**Report: TAB Report**  
**Function: Test, Adjust, & Balance**  
**Date: 12/17/2025**  
**Completed By: National TAB**

## 12-08-25 WAWA #8695 WOODFORD, VA

- EF-1 and EF-2 Rooftop Placement
- EF-2 Duct Drop Size
- EF-2 Motor and Grilles
- EF-2: Improper riser installation
- EF-2: Low total exhaust
- EF-3 Fan Speed
- EF-3: High total exhaust
- RTU-2 Alarms
- RTU-3 Unit Disconnect
- RTU1: CORE board input

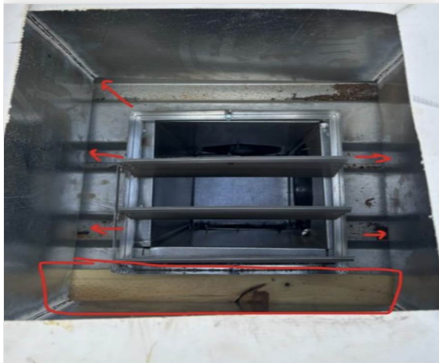
**Issue Name :** EF-2: Improper riser installation  
**Description :** Riser for EF2 is set on top of the roof. 12x12" duct needs to be extended to the top of the curb. Flange needs to be sealed with the top of the curb.  
**Created By :** National TAB                      **Assigned To :** National TAB - Brianna Biggs  
**Status :** Open  
**Priority :** Urgent                                      **Asset Tag :**  
**Originated Date :** 02/16/2026 - Cody Mauro - National TAB

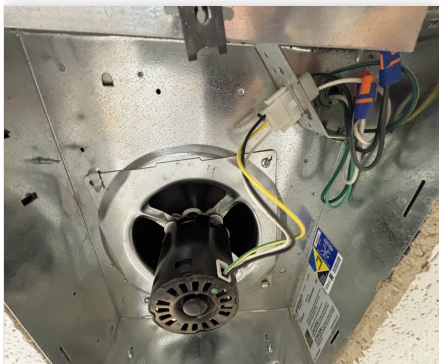
**Issue Name :** EF-3 Fan Speed  
**Description :** Unit is not equipped with a fan speed controller, currently running at max speed.  
**Created By :** National TAB                      **Assigned To :** National TAB - Brianna Biggs  
**Status :** Open  
**Priority :** [Medium](#)                                      **Asset Tag :**  
**Originated Date :** 12/19/2025 - John Barresi - National TAB

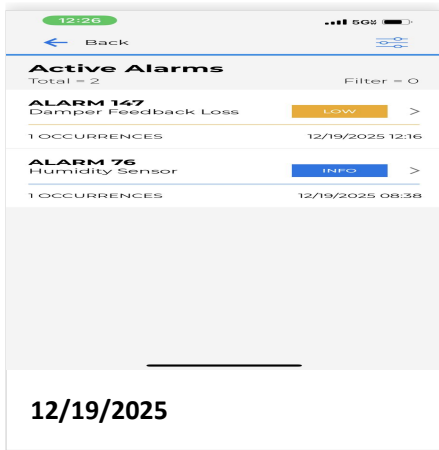
**Issue Name :** EF-3: High total exhaust  
**Description :** EF3 total exhaust ~15% high of design. Single phase motor, wired at high speed.  
**Created By :** National TAB                      **Assigned To :** National TAB - Brianna Biggs  
**Status :** Open  
**Priority :** Low                                      **Asset Tag :**  
**Originated Date :** 02/16/2026 - Cody Mauro - National TAB

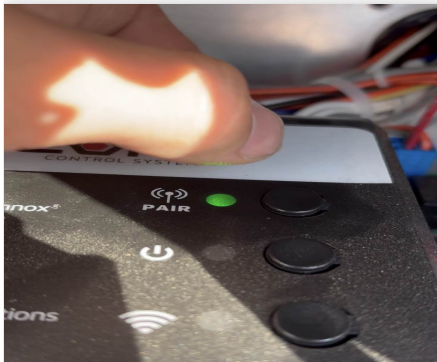
**Issue Name :** RTU-3 Unit Disconnect  
**Description :** Unit disconnect switch cover is misaligned, unable to access/use switch unless cover is taken off.  
**Created By :** National TAB                      **Assigned To :** National TAB - Brianna Biggs  
**Status :** Open  
**Priority :** Low                                      **Asset Tag :**  
**Originated Date :** 12/12/2025 - John Barresi - National TAB
